Technical Service Bulletin – 50

Mustang Dark Horse R Ballast Cover Update – Required

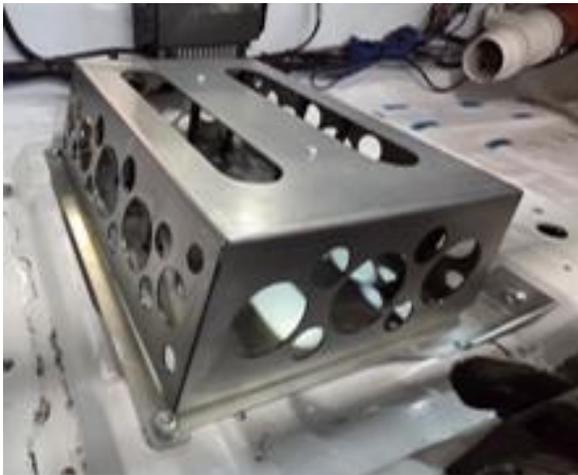
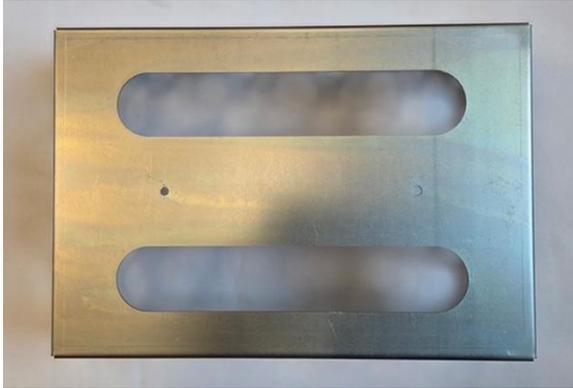
Purpose: To improve driver egress during an emergency.

Action: Replace the original Ballast Cover part # 20017-03-0182AA01 and Wing Nuts with Ballast Cover part # FR-6170-A and Button Head Screws, M6-1.0 x 10mm, property class 12.9.

Remove 2 M6-1.0 Wing Nuts and Ballast Cover # 20017-03-0182AA01.

Install steel Ballast Cover, # FR-6170-A and 2 M6-1.0 x 10mm Button Head Screws property class 12.9, torque to 14Nm(10ft-lb).
